## STAFF REPORT

### Guild Road Industrial

<b>Land Use Application Nos.:</b>	CAP-22-001 (Critical Area Permit) SPR 22-006 (Site Plan Review – Type 2) SEP 22-006 (SEPA) VAR-22-002 (Major Variance)
<b>Applicant &amp; Owner:</b>	Part IV Properties C/O Dennis Wubben 12313 NE 99 <sup>th</sup> Street Vancouver, Washington, 98682
<b>Site Location:</b>	Unaddressed
<b>Parcel &amp; Size:</b>	508350100, 4.31 Acres
<b>Zoning Designation:</b>	Light Industrial, I-1
<b>Date Application Received:</b>	June 28 <sup>th</sup> , 2022
<b>Notice of Application &amp; Likely DNS issued:</b>	August 19 <sup>th</sup> , 2022 [See: case # SEP-22-006]
<b>Comment Period &amp; SEPA Appeal Period Ended:</b>	September 14 <sup>th</sup> , 2022
<b>Staff Report Issued:</b>	October 27 <sup>th</sup> , 2022
<b>DRC Recommendation:</b>	Approve with Conditions
<b>Hearing Date:</b>	November 1 <sup>st</sup> , 2022, 1:30PM <a href="https://meet.goto.com/310832213">https://meet.goto.com/310832213</a>

## **IV. ADDENDUM "D" PLANS**

STREET AND UTILITIES PLAN

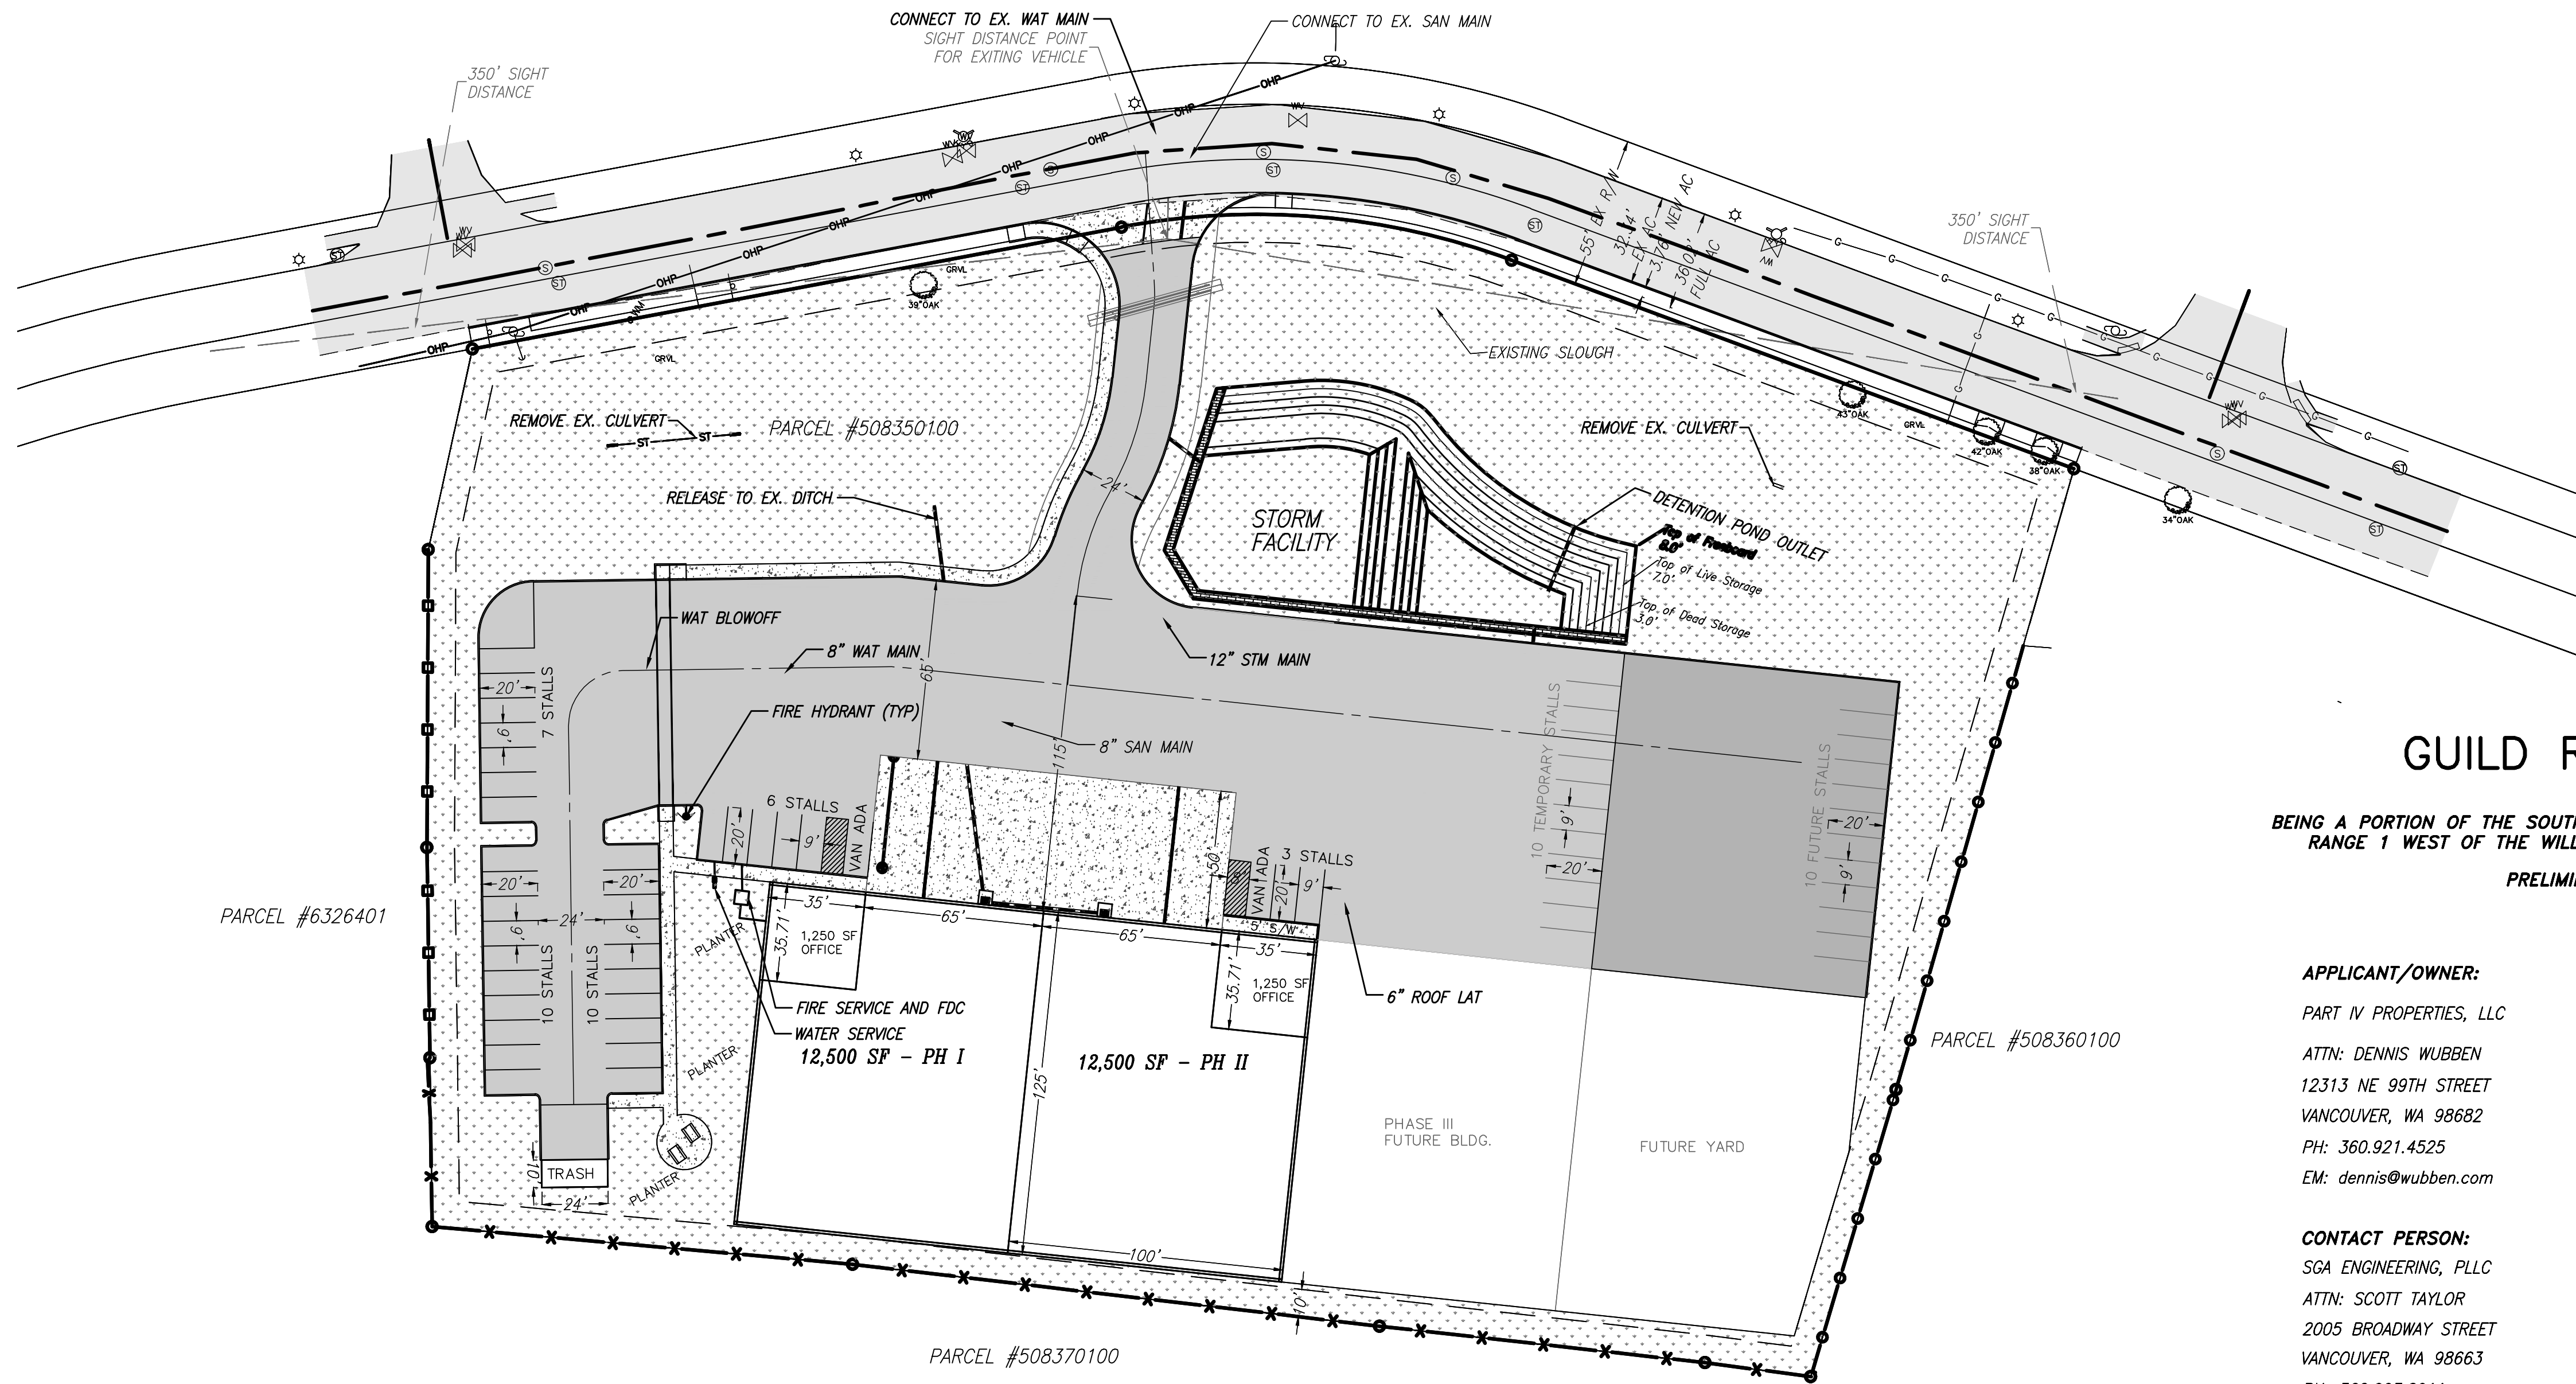
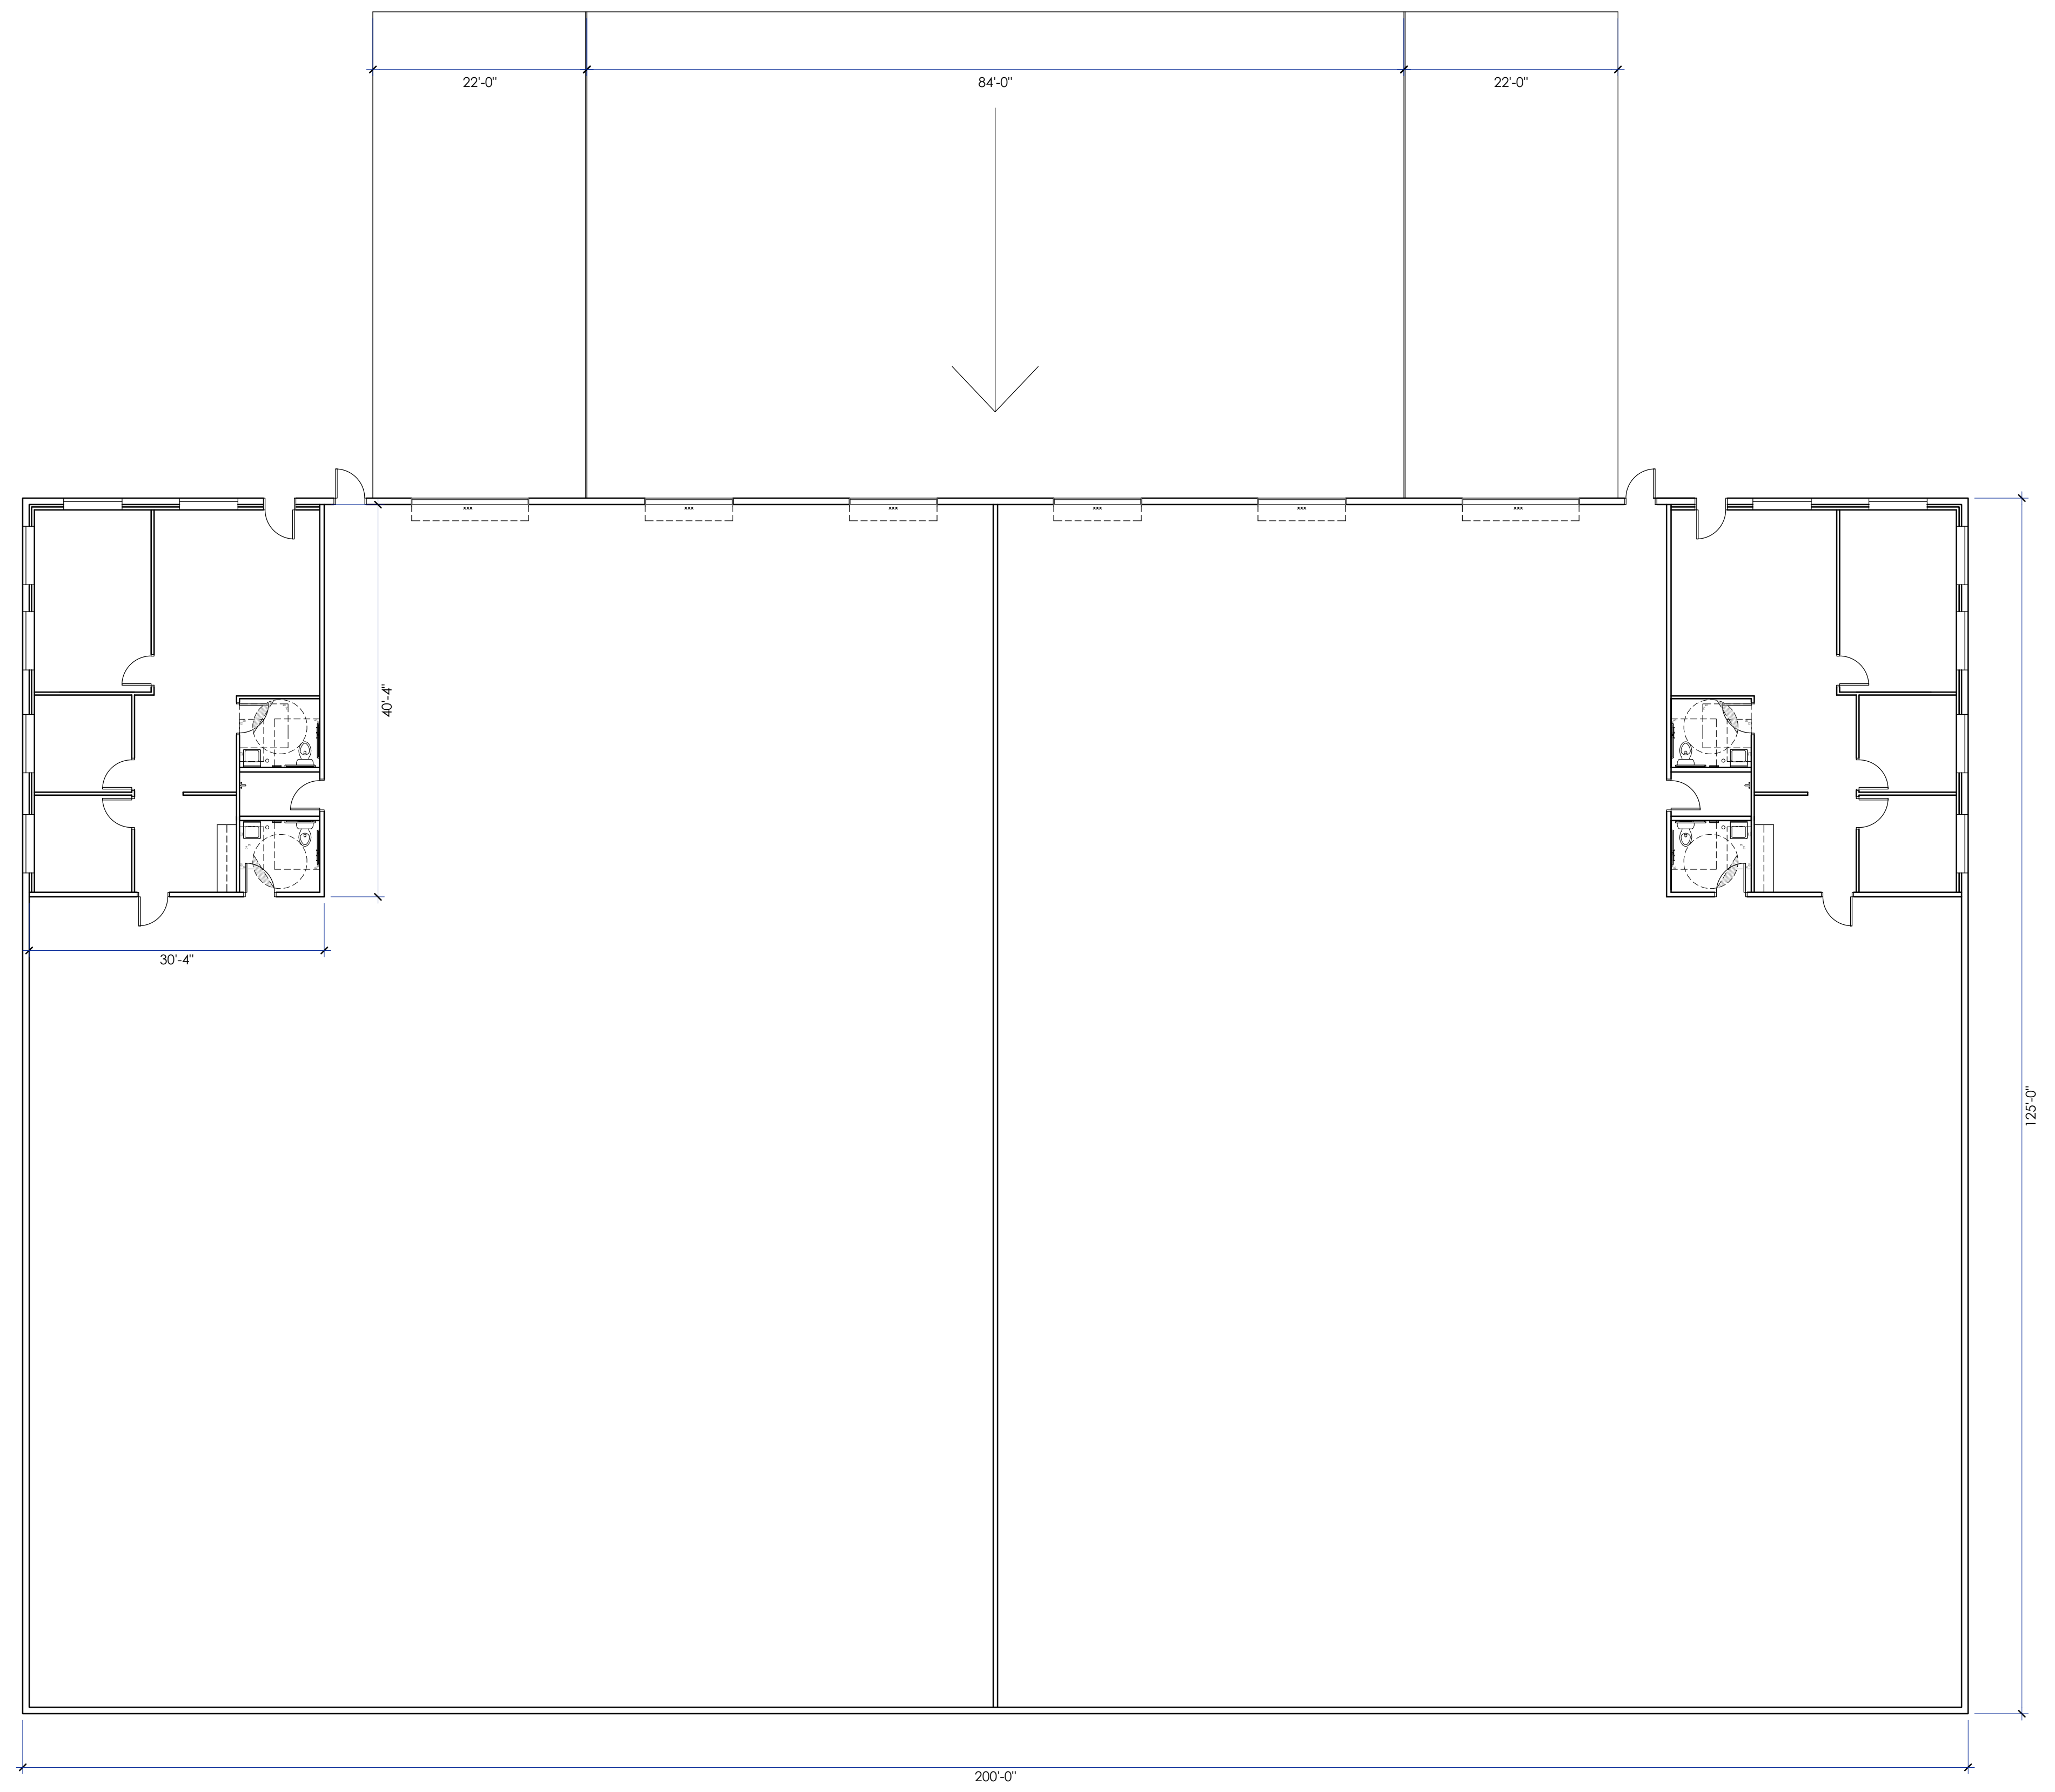
**Finding 8:** The proposed landscaping plan does not identify street trees along the frontage along Guild Road. Applicant will be required to identify street trees prior to final/civil engineering approval as is consistent with the City of Woodland's approved street tree list as outlined within the small street tree list that can be found online here: <https://www.ci.woodland.wa.us/publicworks/page/street-trees> (See condition 4)

**Finding 10:** Proposed frontage improvements has not been identified on preliminary plans, however the applicant acknowledges within the narrative provided that, "Public frontage improvements along Guild Road will be completed to add sidewalk, curb, and gutter." Applicant shall provide full civil plans for City review and approval with their civil review application. (See condition 7)

Specifically, a 100-foot riparian habitat buffer would impact six parking spaces located at the far-Northwest corner of the parking lot and three at the far-northeast corner of the parking lot. The buffer area would also functionally isolate the twenty parking spaces in the rear of the property.

Staff is recommending that a major variance be approved with conditions permitting a reduced 40-foot Riparian Habitat buffer, rather than the applicant's proposed reduced buffer that ranges from 26 to 50 feet. Staff has determined that the proposed development can meet this 40-foot buffer with minor modifications, primarily to the northwestern corner of the parking lot and the pedestrian access point(s). A 40-foot buffer would require to realignment of the pedestrian access path from the Western to the Eastern side of the property, and the redesign of the northwestern corner of the parking lot to accommodate a 40-foot buffer. Based on preliminary calculations, this redesign of the parking lot would only require cutting out a 40 ft by 10 ft section. (See *Condition 26.d*)

- c. An approved variance expires after three (3) years unless a building permit has been issued and substantial construction taken place.
    - d. Provide an updated site plan with civil engineering submission demonstrating that the updated site design complies with a 40-foot Riparian area buffer.
